Model No. **SA-XH10EE**

Subject : Block Diagram, Schematic Diagram, Printed Circuit Board & Replacement Parts List (Updates).

Please file and use this supplement manual together with the service manual for

SA-XH10GC/GW MAIN CIRCUIT

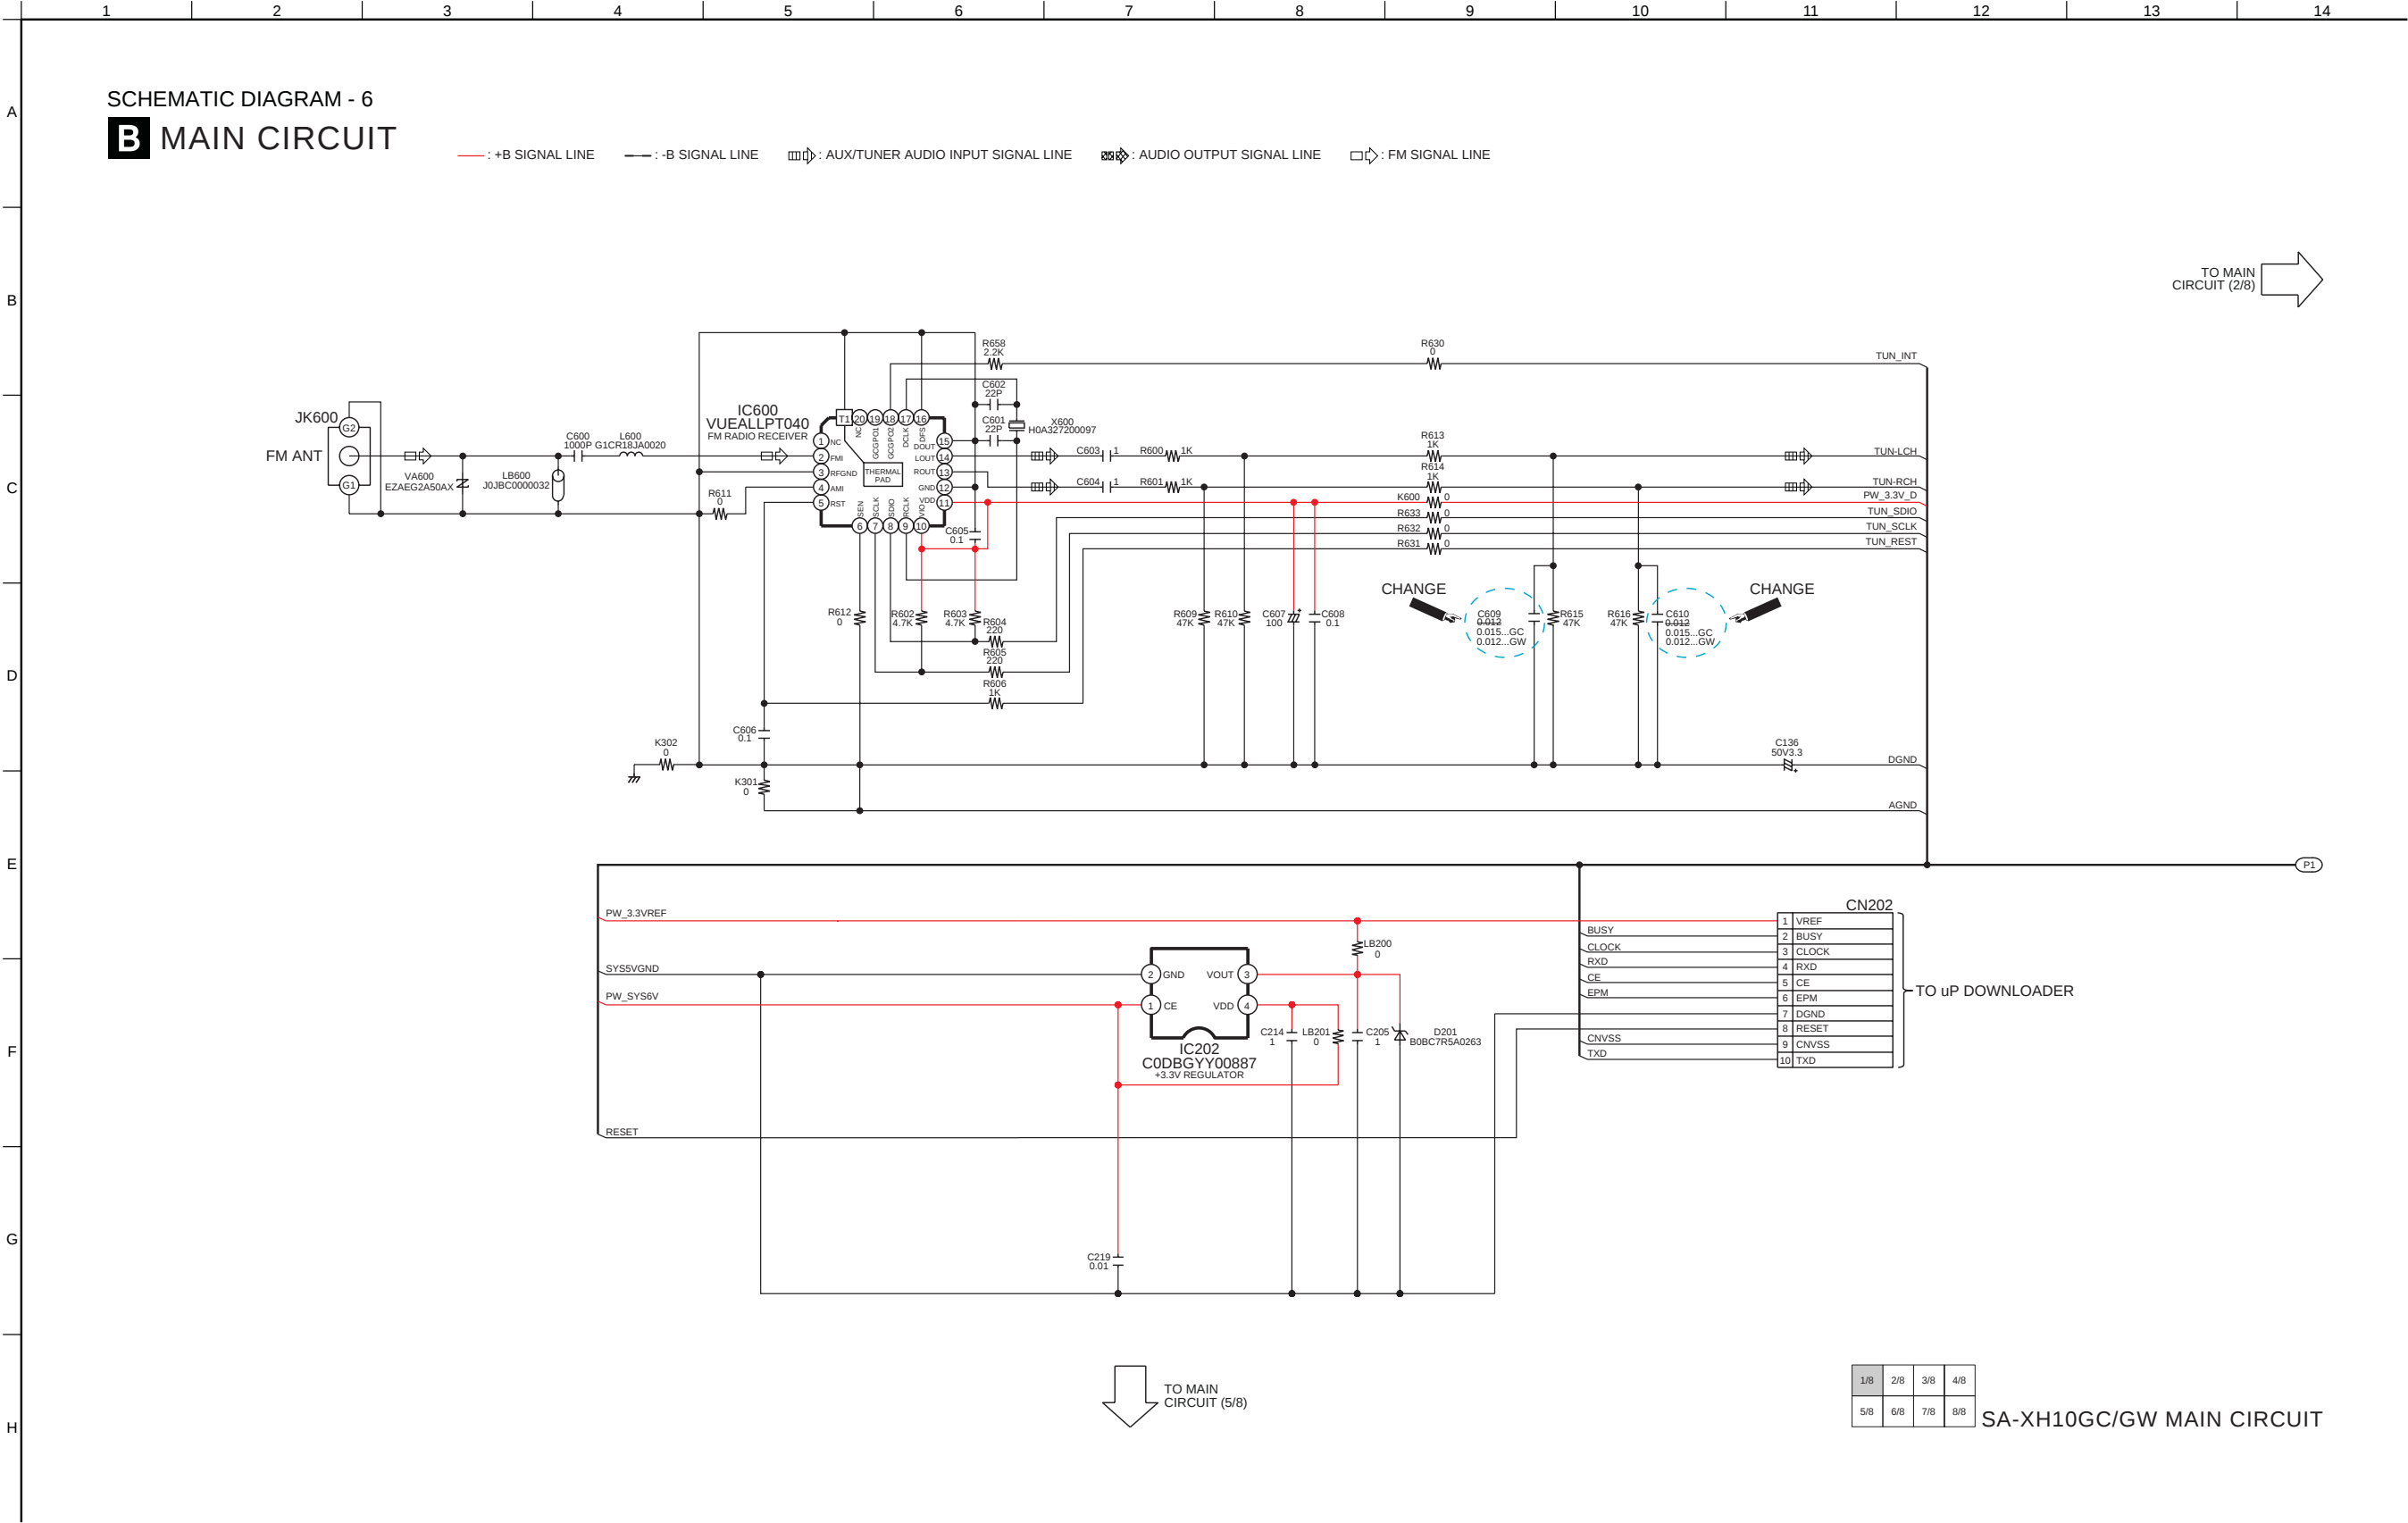
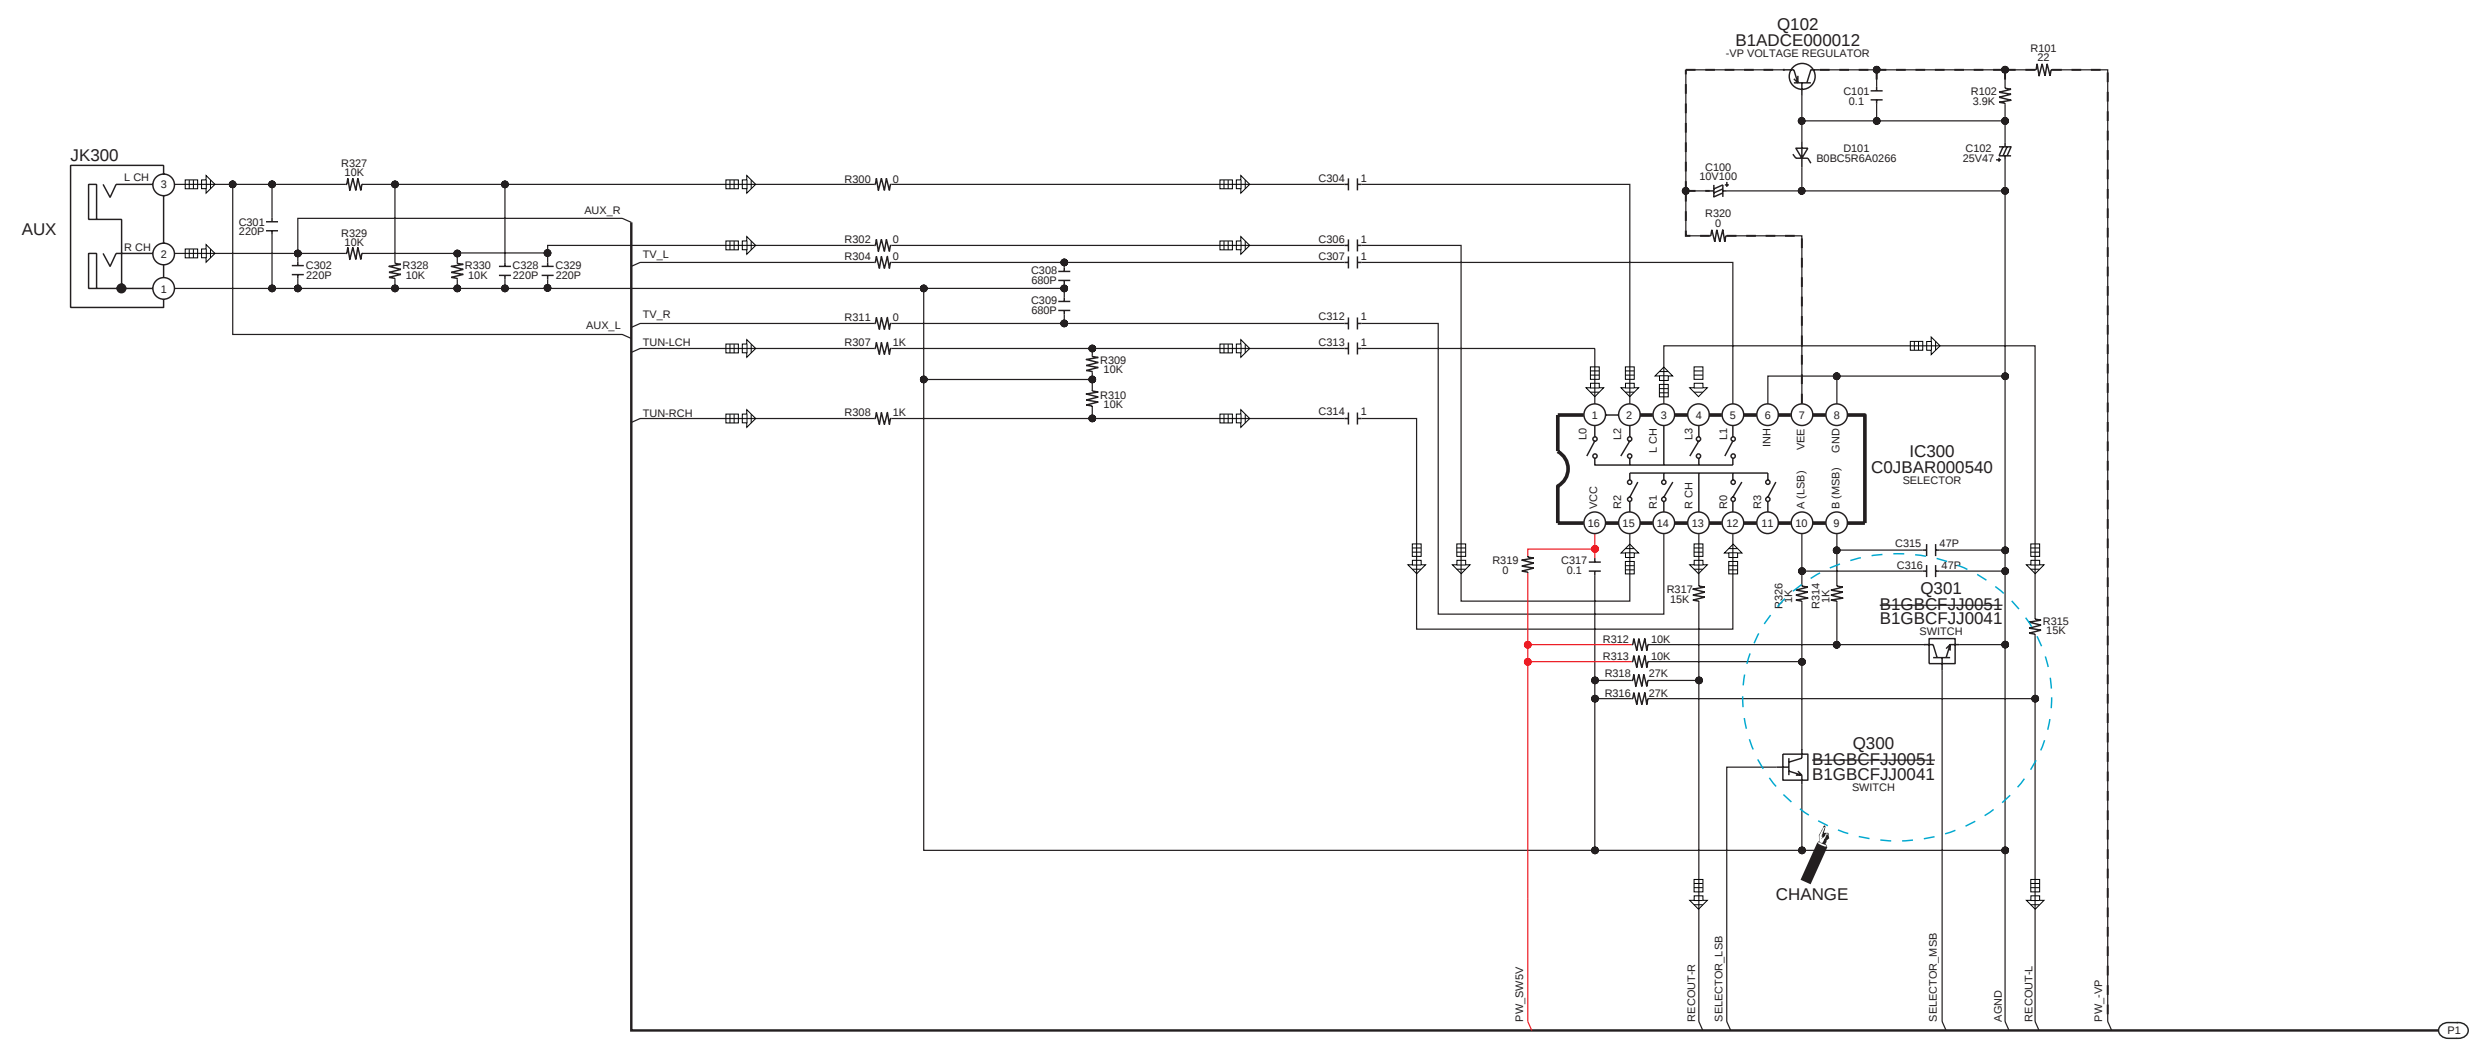
Q501 B1ABCF000011 B1ABCF000231 SPEAKER PROTECT SWITCH

Q500 B1ABCF000011 B1ABCF000231 SPEAKER PROTECT SWITCH

CHANGE
